RE: DRAINAGE PLAN FOR PONDEROSA RESERVOIR (G-21/D28)
ENGINEER'S STAMP DATED MAY 3, 1988

To:
Subject: PONDEROSA RESERVOIR NO. 2

Re: Drainage Analysis at Ponderosa Reservoir No. 2
URS Project No. 46801

FIGURE 3

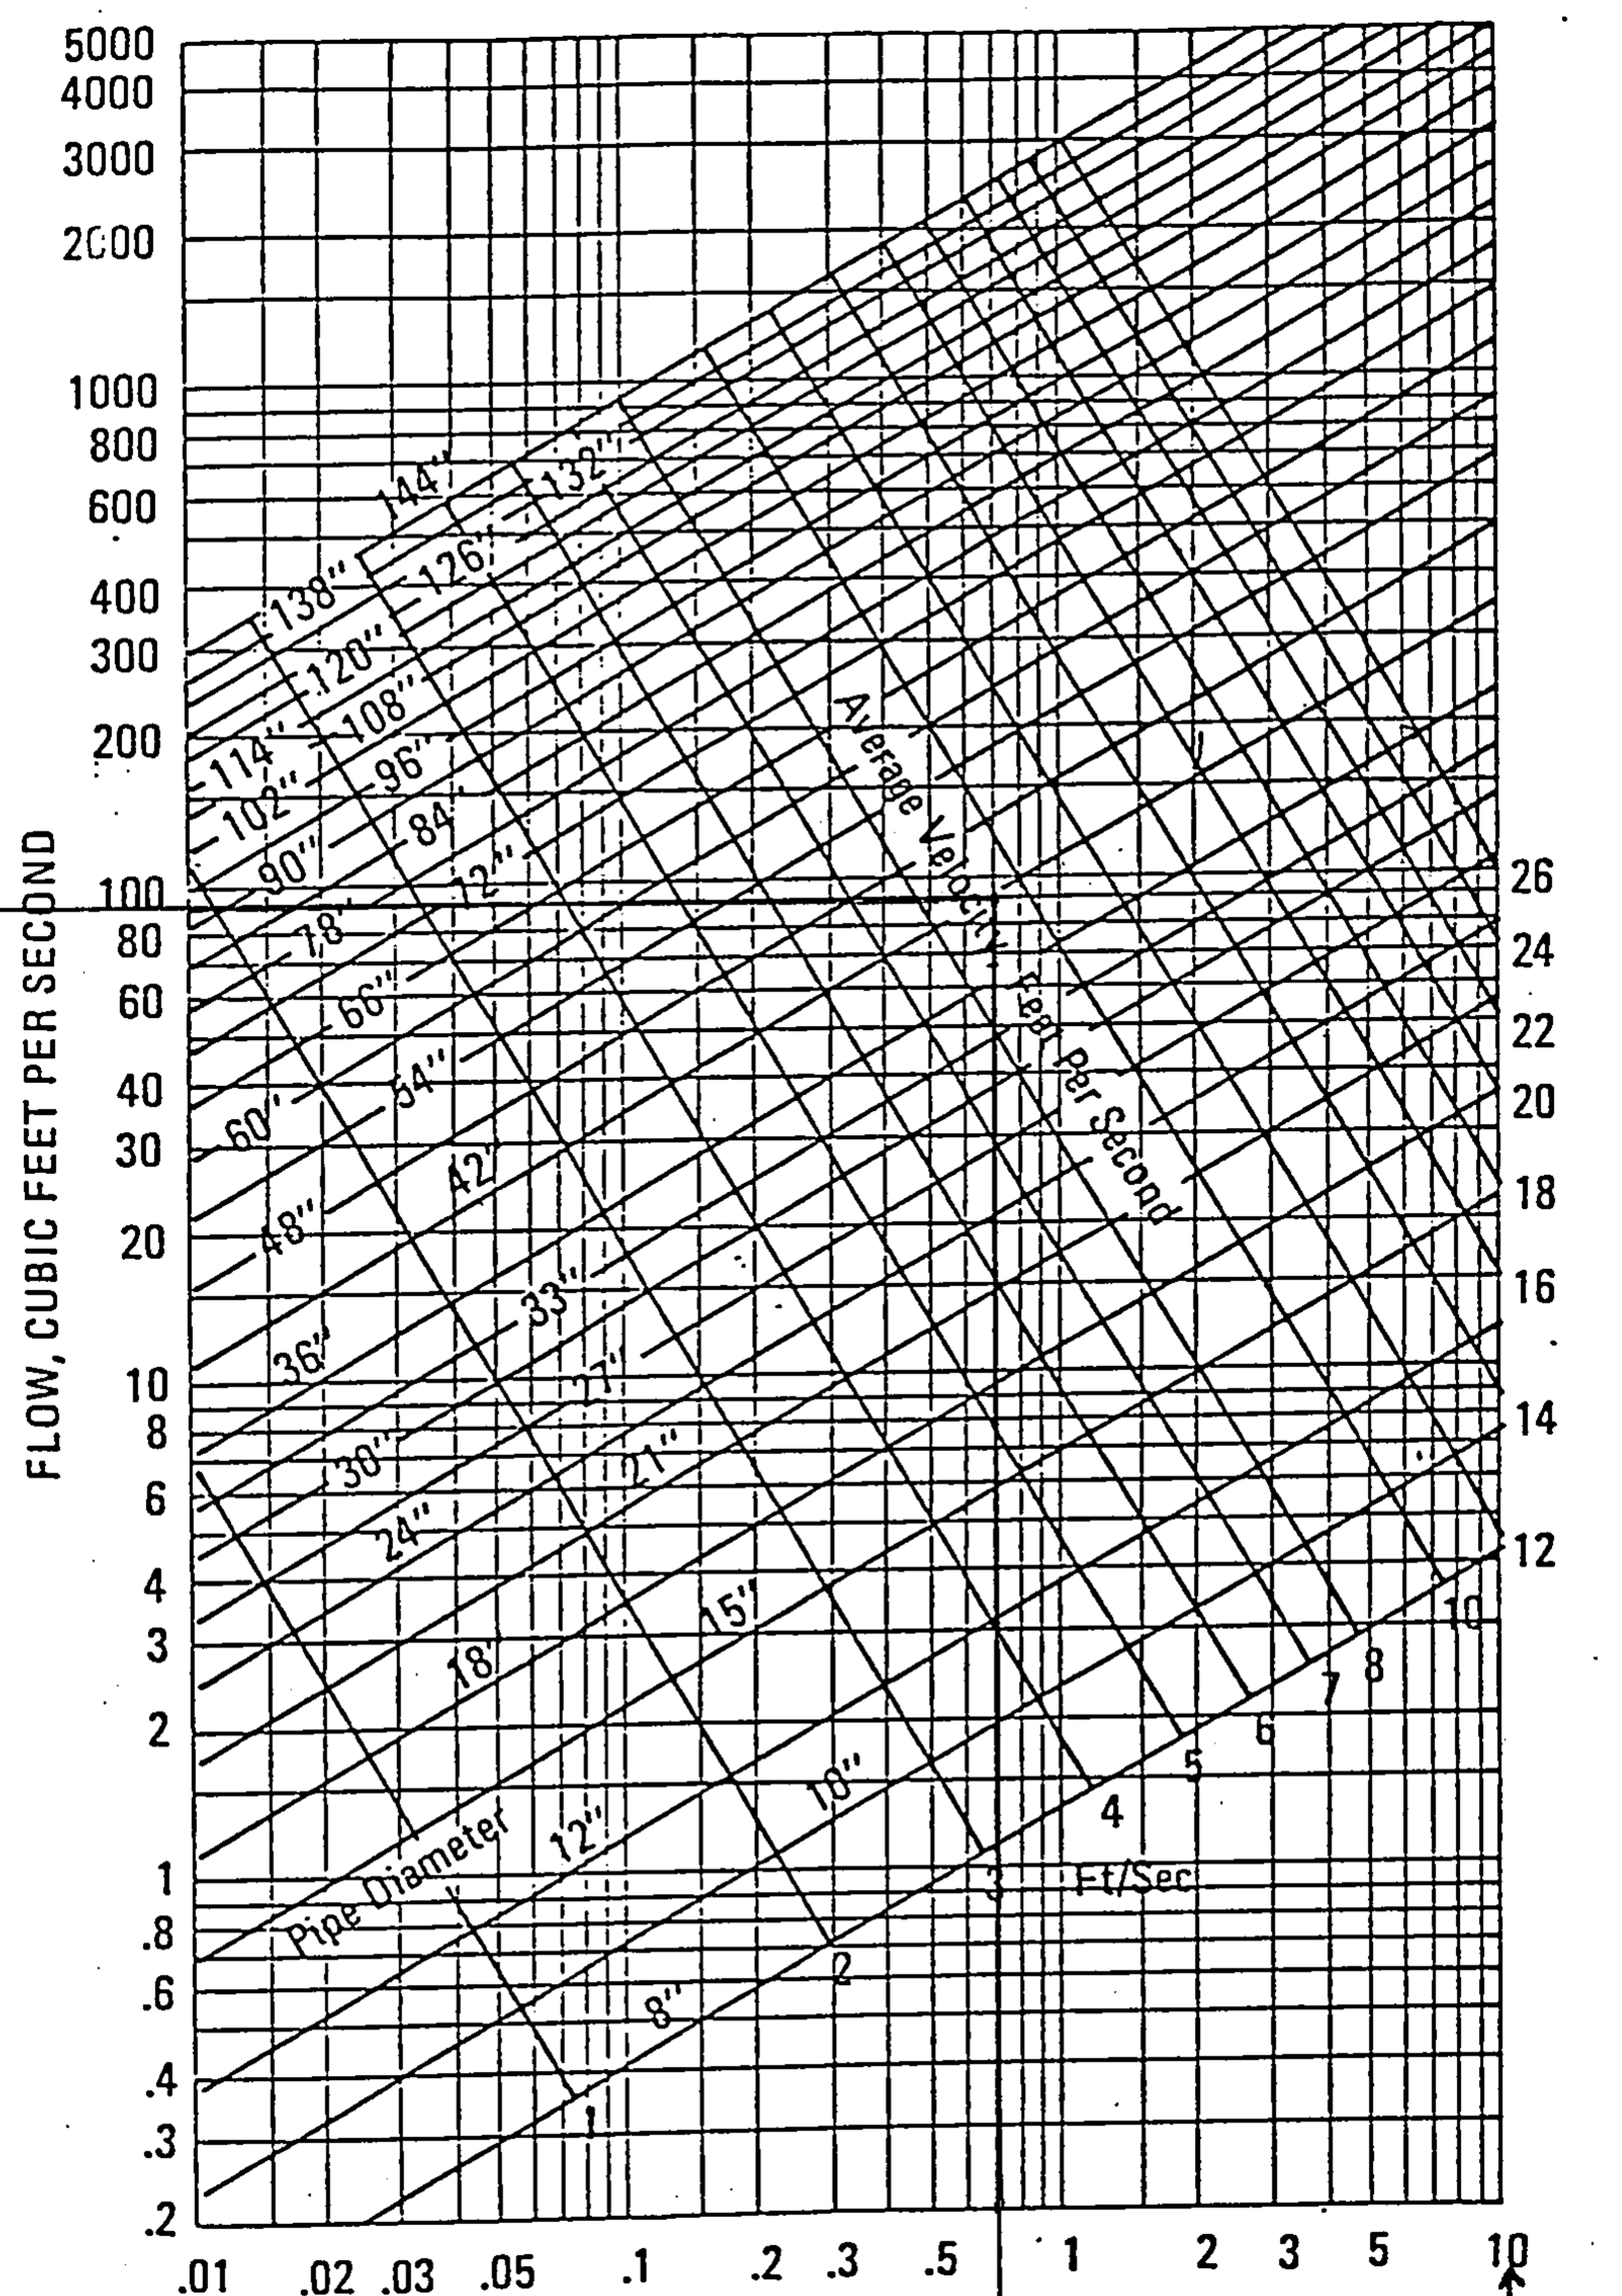
Existing 42" Storm Drain in Morris Can carry 90cfs

figure 1

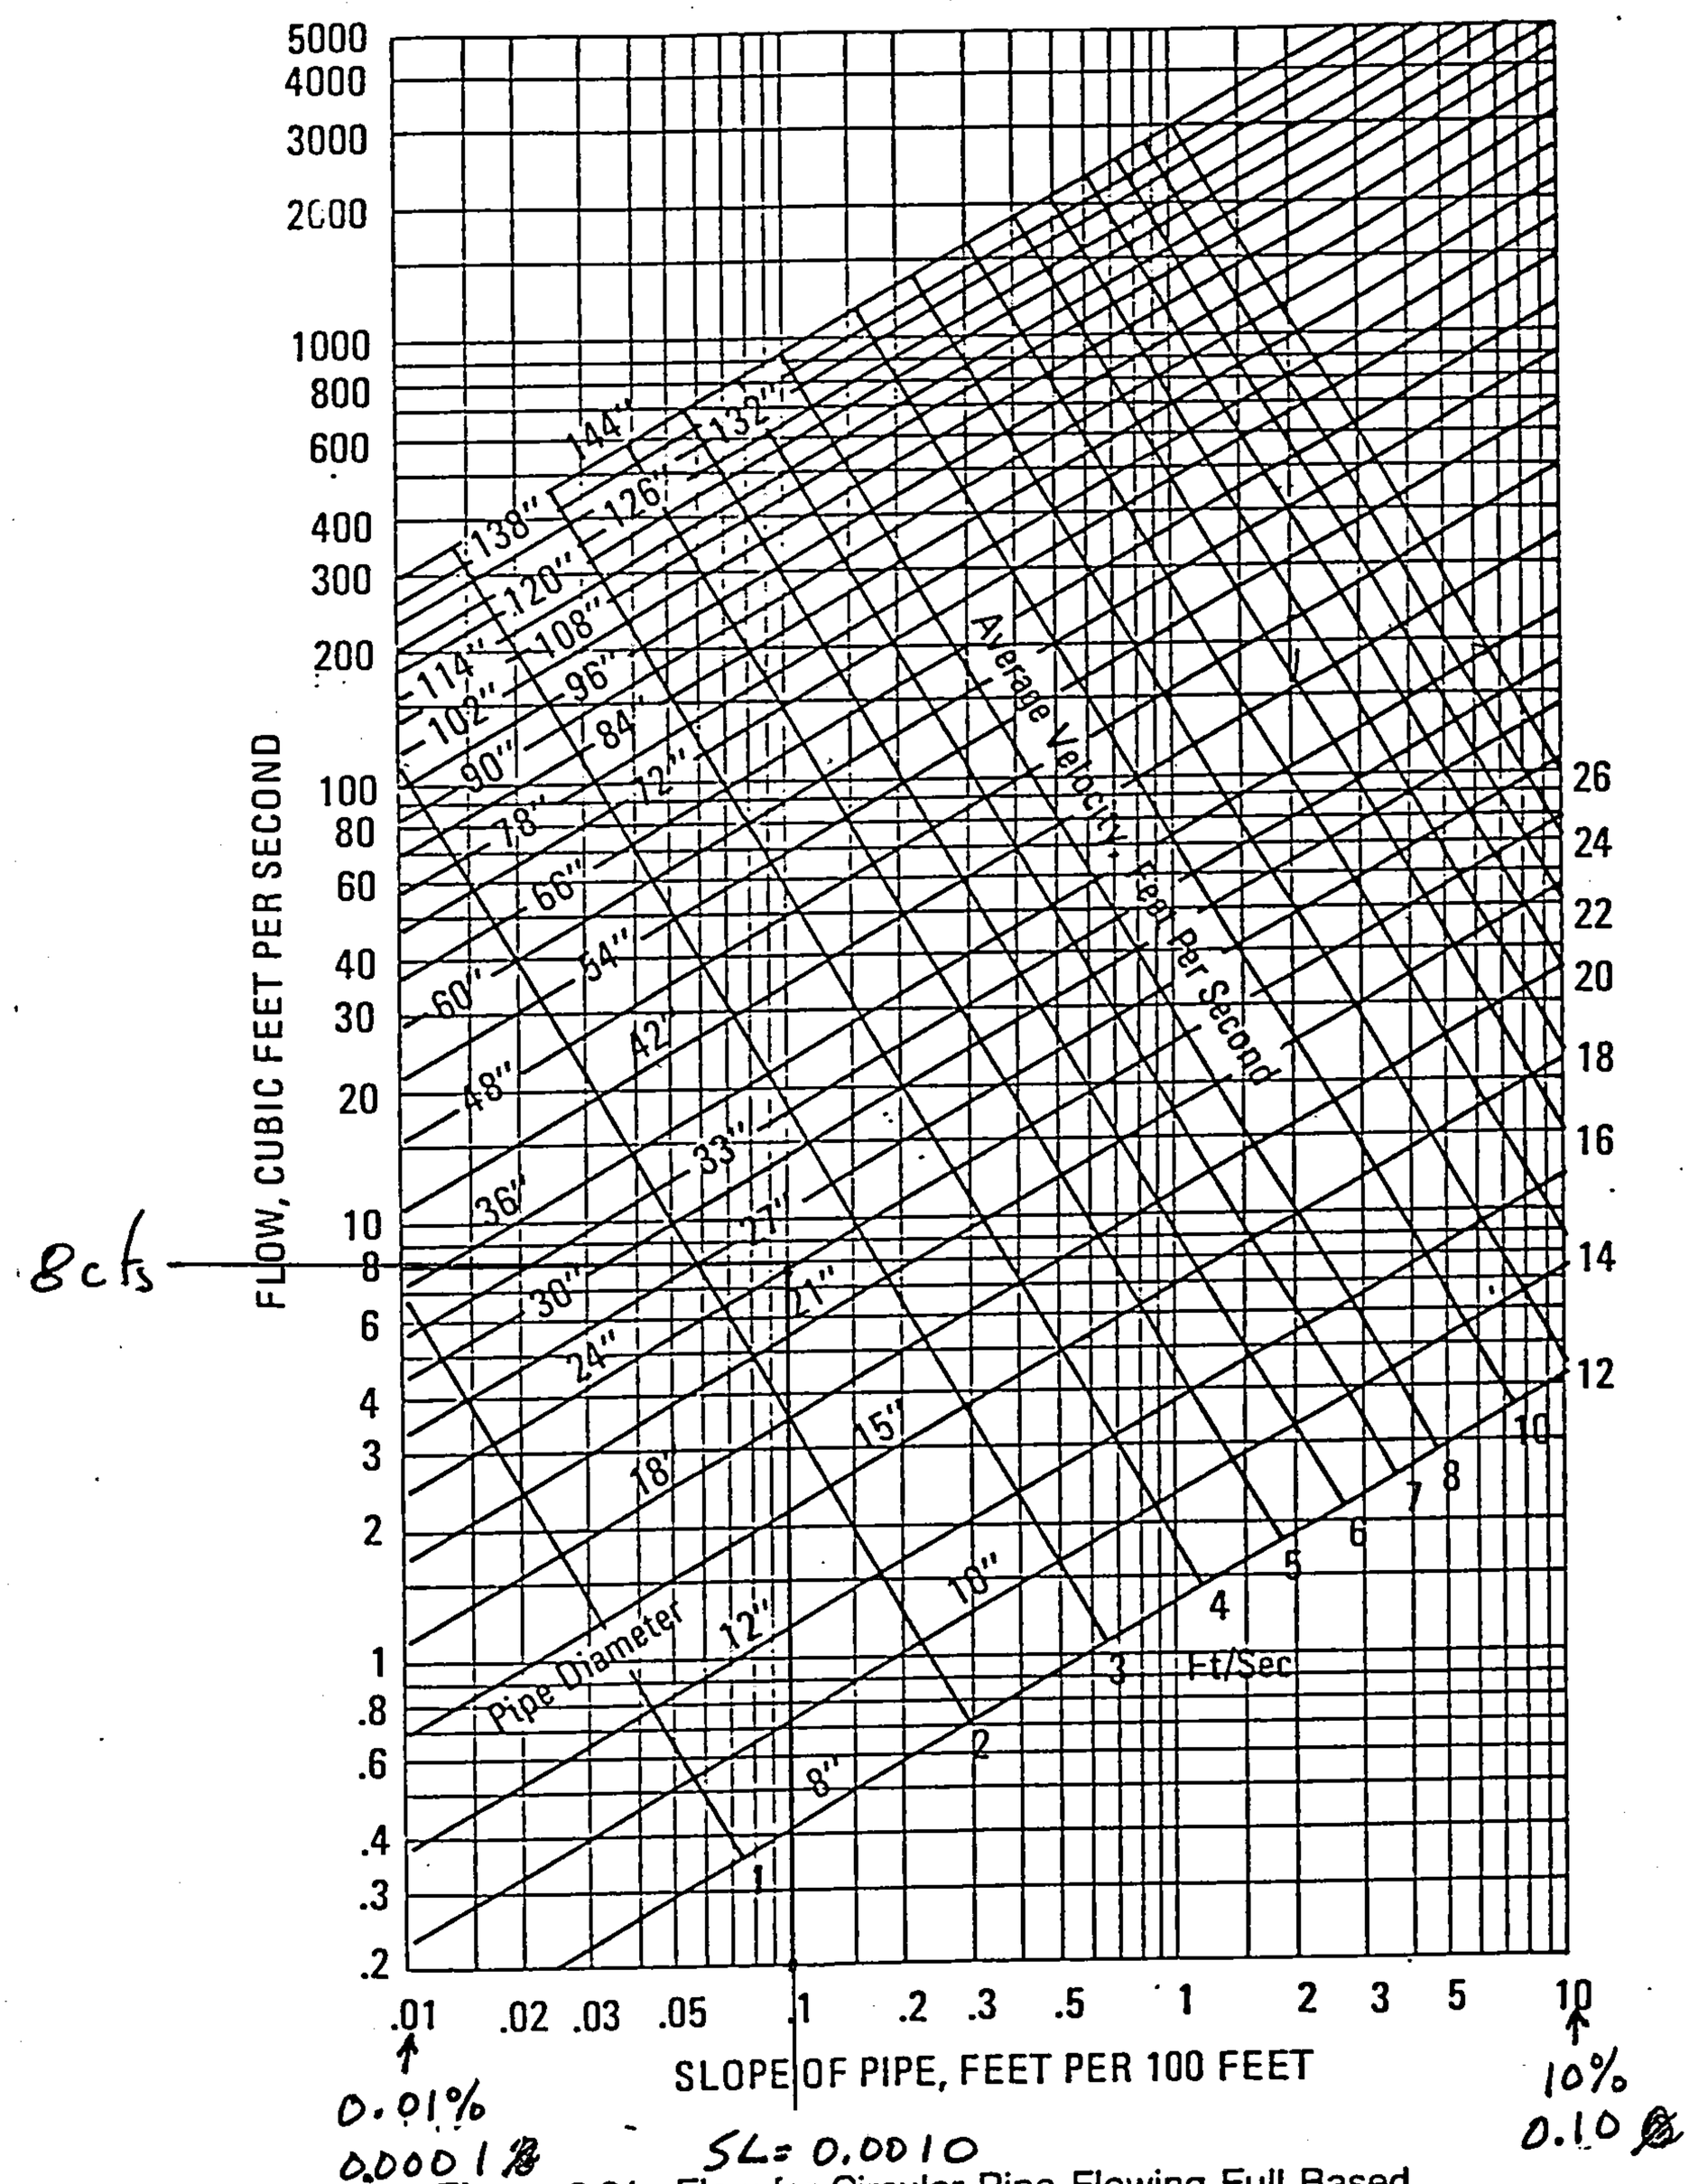
~~Ex~~isting 24" storm Drain in MONTGOMERY CAN ONLY CARRY 8 cfs

Figure 2

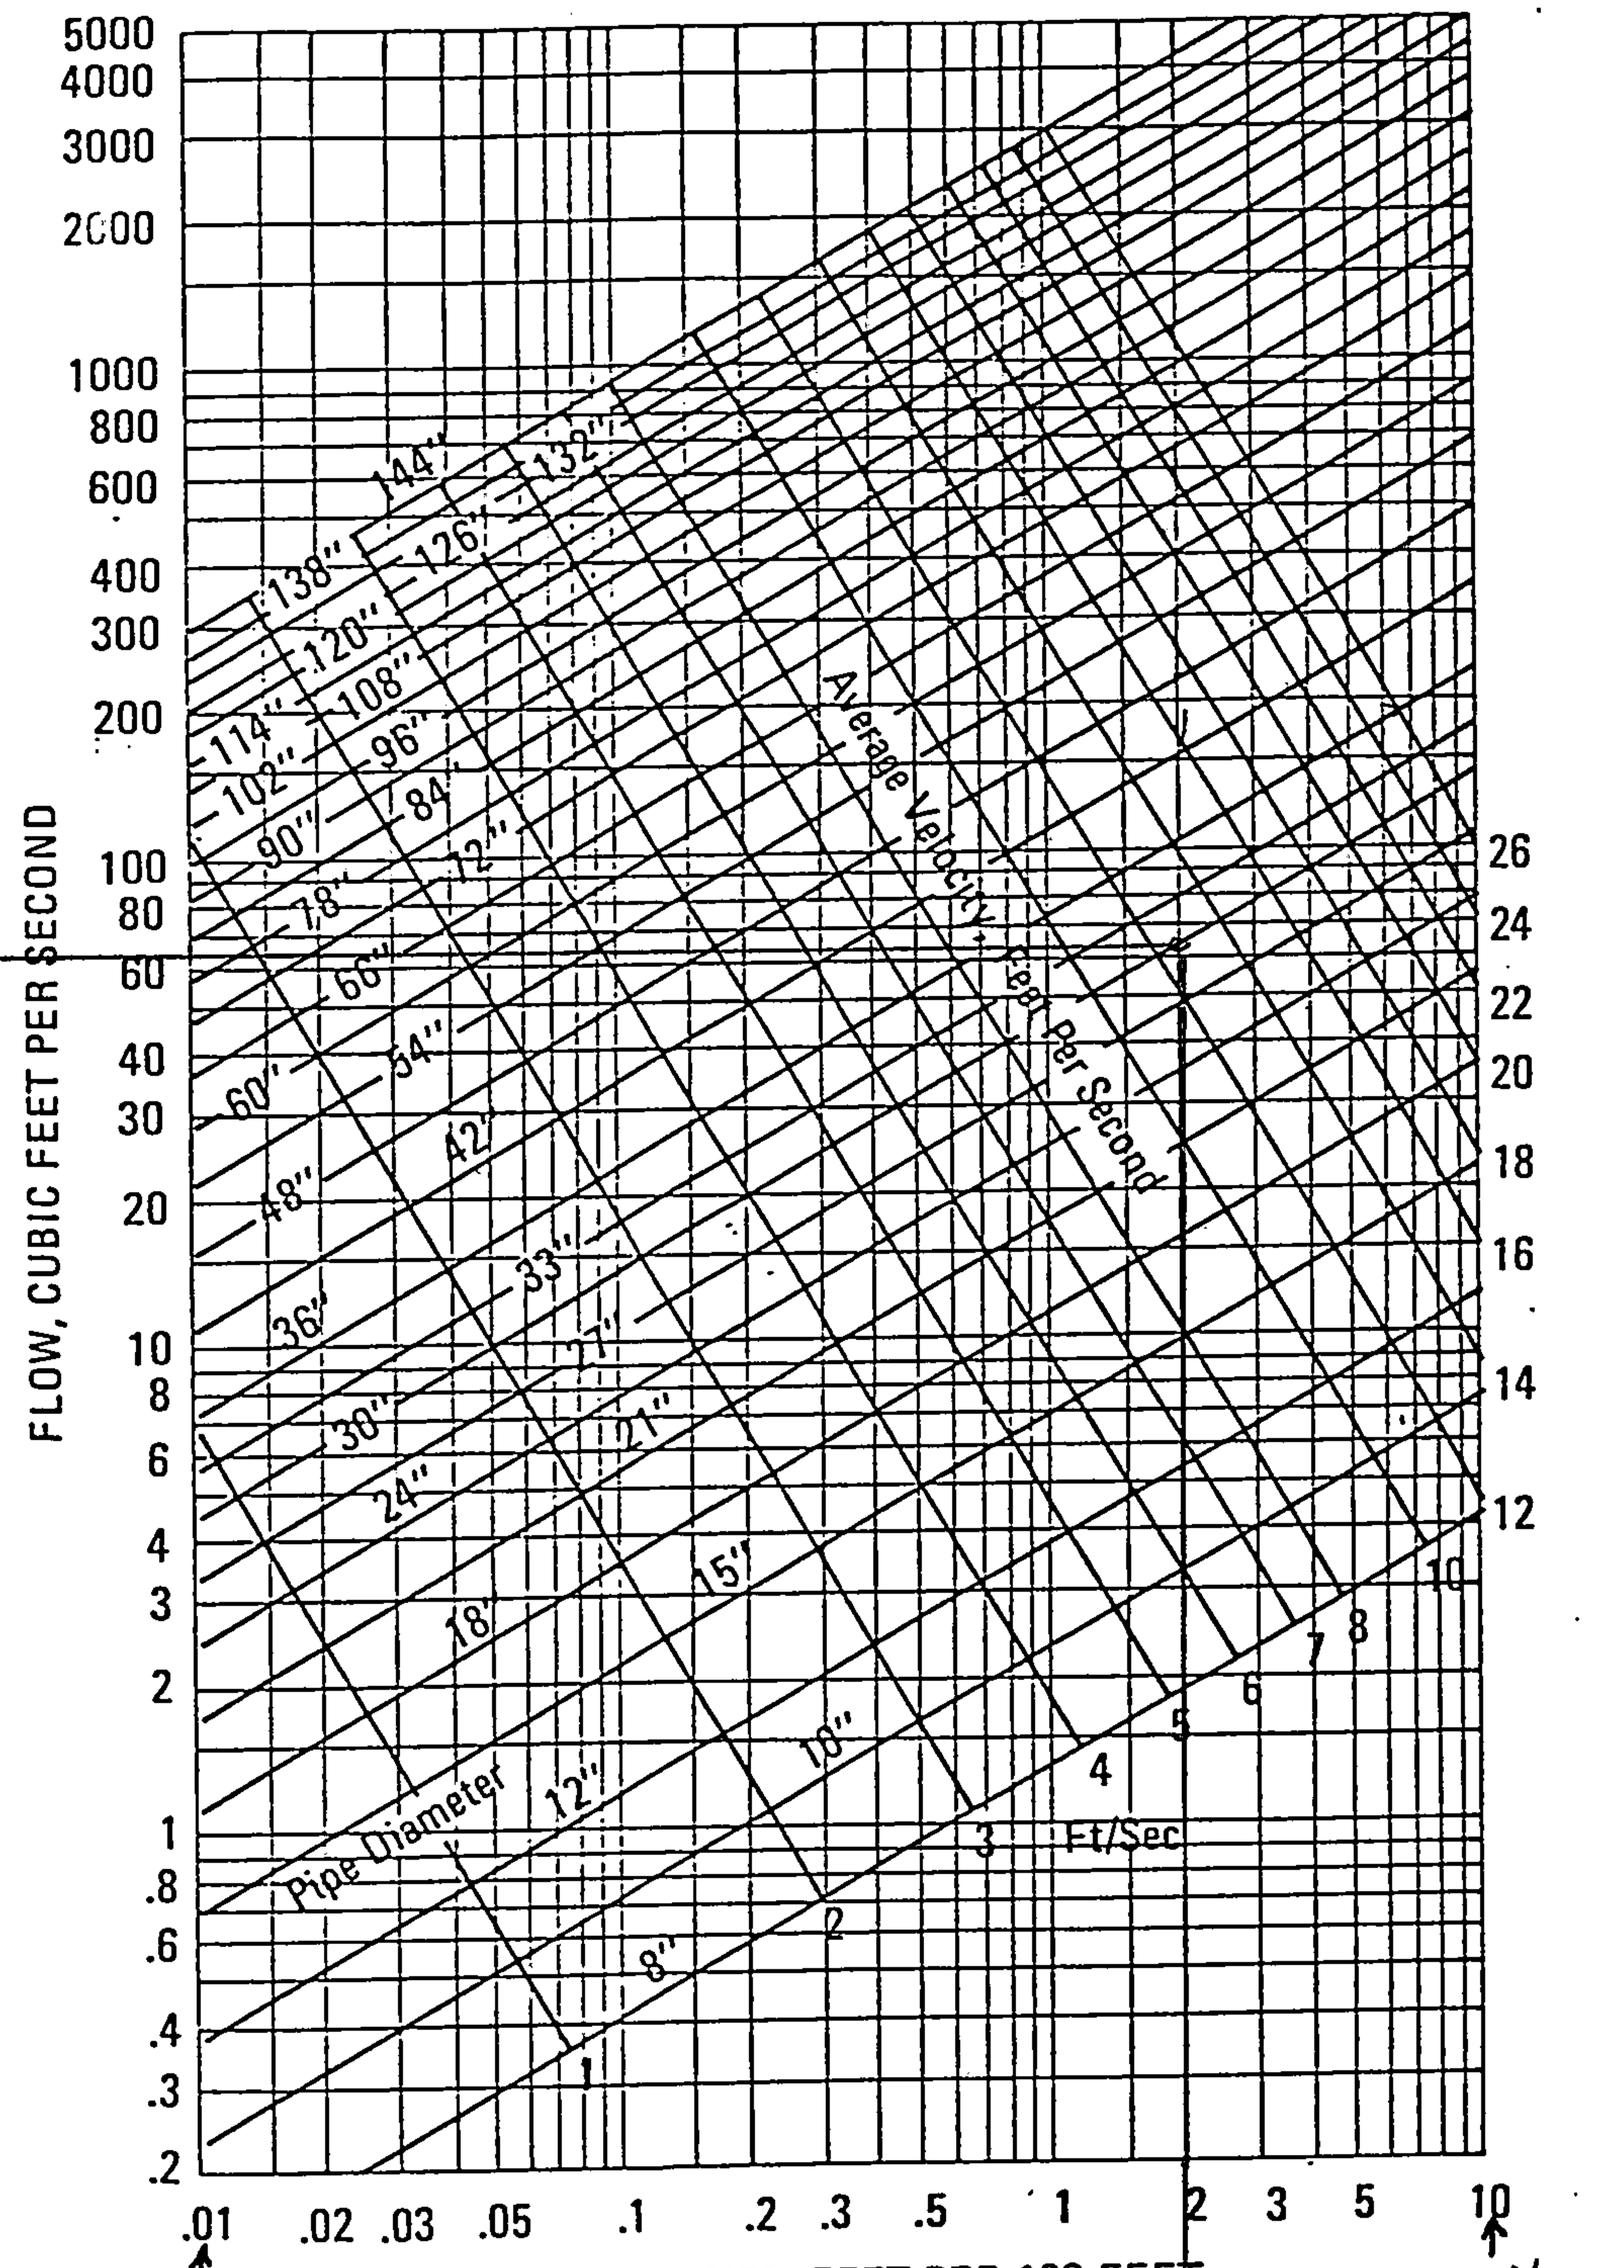
— Existing 30" Storm Drain in Cielito Lindo
Can carry 60 cfs
